Delegated Report

Householder Planning Application

Planning Application No:	20240474
Location:	Halfacre, Round Street, Cobham, Gravesend
Description:	Proposed front extension and the erection of a front porch.
Applicant:	Mr Robert Shotton
Site Visit Date:	Desktop assessment (see previous case)

Proposed Floor Plan:

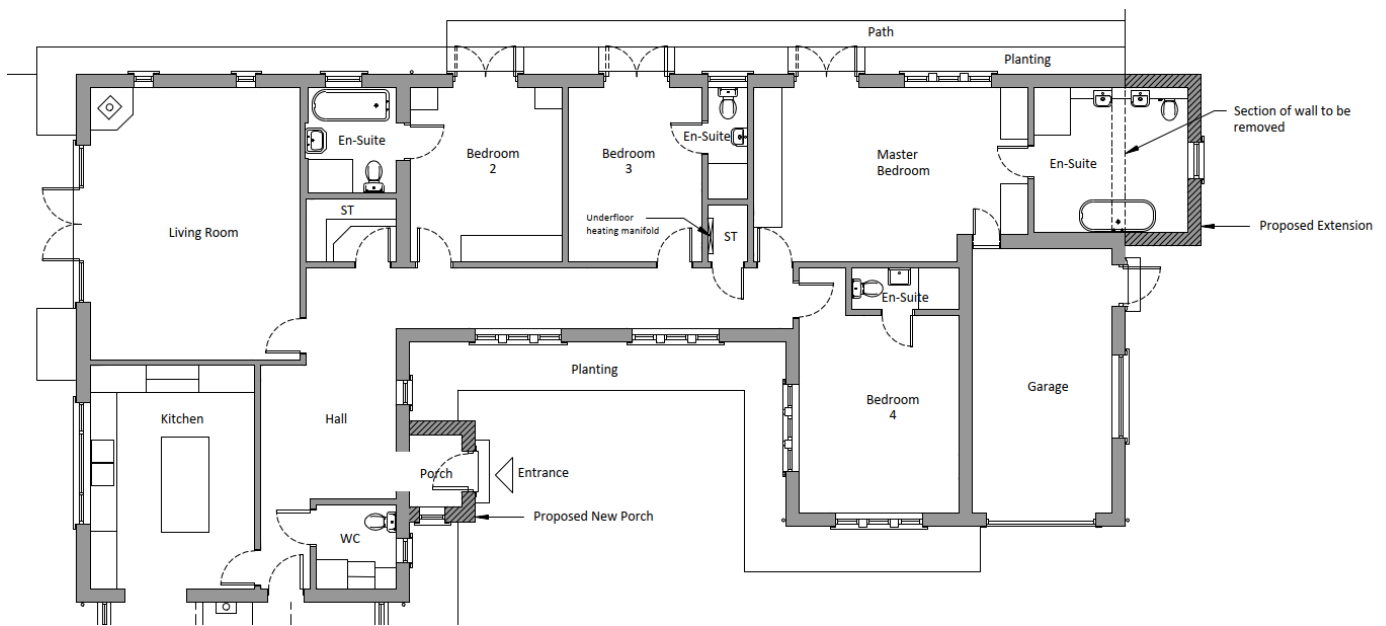
The proposed porch will project approximately 1.5m to the front, 2.2m wide and 3.3m to the top of the pitched roof. The front extension will be approximately 3.9m to the top of the pitched roof, will project 1.7m to the front and will be 3.8m wide. The extensions will be rendered to match the existing materials, with matching roof tiles and window.

Proposed Elevations:

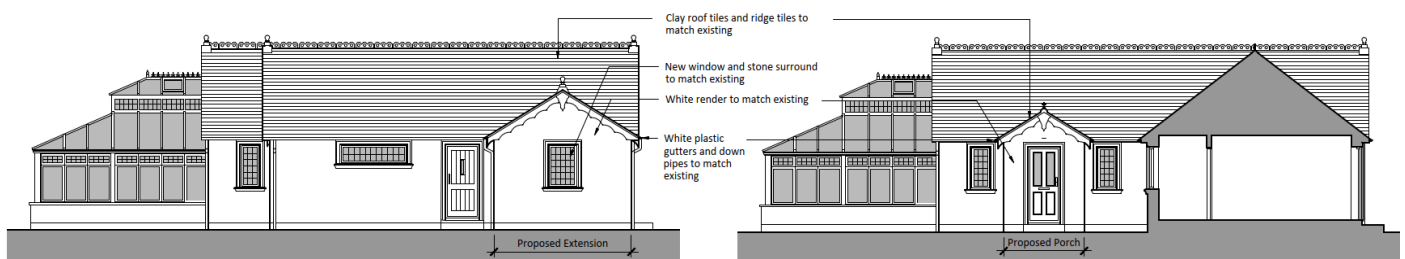
The proposed porch and front extension are both modest, single storey and subservient additions to a detached house that is separate from neighbouring buildings. The additions will not be visible from the public realm as the property is on a backland plot. The proposed extensions will match the appearance of the main building and will fit seamlessly onto it.
